PUD15-00005 & CVA15-00019 / DevCo

Summary

The applicant is requesting a conditional use permit for a 196 unit planned residential development on 7.89 acres located at 2105 S. Federal Way in an L-OD (Limited Office with Design Review) zone. A variance to reduce the street side setback along Hudson Avenue is included.

Planning Division Project Report

(Recommended Sidewalk Connections)

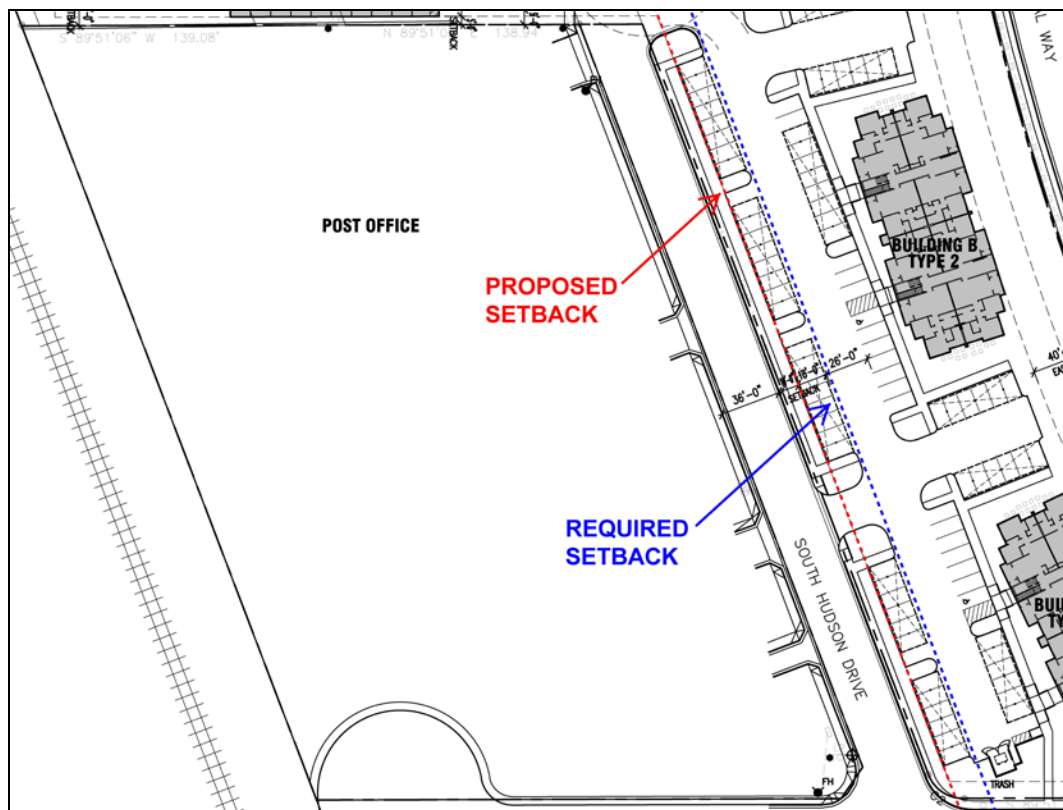
There also appears to be an opportunity to increase pedestrian connectivity and safety within the project. Specifically, clearly delineated crosswalks could be provided at each of the entrances. As illustrated above, a recommended condition of approval requires defined crosswalks at each of the entrances. This can be accomplished through a combination of striping and changes in paving material, color, and/or grade.
